## **STAFF REPORT AND RECOMMENDATION TO THE DESIGN COMMISSION**

CASE FILE: LU 13-189059 DZM – Abigail Apartments  
Pre-App.: EA 12-180268 PC  
REVIEW BY: Design Commission  
WHEN: Thursday November 21, 2013 @ 1:30 pm  
WHERE: 1900 SW Fourth Ave., Room 2500A  
Portland, OR 97201

**C.15** Basement Plan

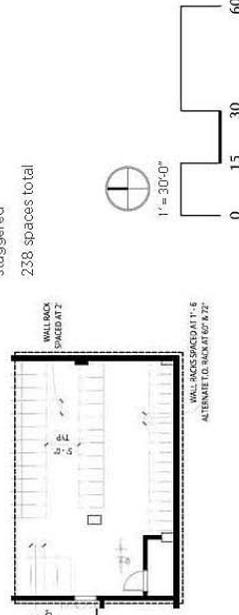
33,266 220.C Standards for Bicycle Parking:  
A space 2'-0" by 6'-0" must be provided for each required bicycle parking space.

We would like to provide more bike parking and more of those spaces as floor racks within the allocated space. This project is oriented towards families with children. This means that we will have larger extended bikes and trailers that are best secured to floor racks. At the same time, we will have children's bikes that take up less space. We propose the following alternate:  
58 floor racks at 24" oc  
80 wall racks at 18" oc vertically staggered  
238 spaces total

Modification #2 – Bike Parking Stall Width: Bike parking is provided in excess of the code requirement, and the applicant has revised the basement bike parking layout to reduce the number of reduced width stalls from 208 to 100. The wall-mounted staggered vertical rack system has a stagger and allowance for sliding hangers that will assist in the hanging and locking of bikes. Additionally, the loops to which the bike are hung project out of the wall 27” to further ease bike hanging. A 5’-0” aisle is still provided adjacent to each rack, and the Zoning Code does not yet establish a distinction between minimum dimensions for wall hanging spaces versus floor mounted spaces.
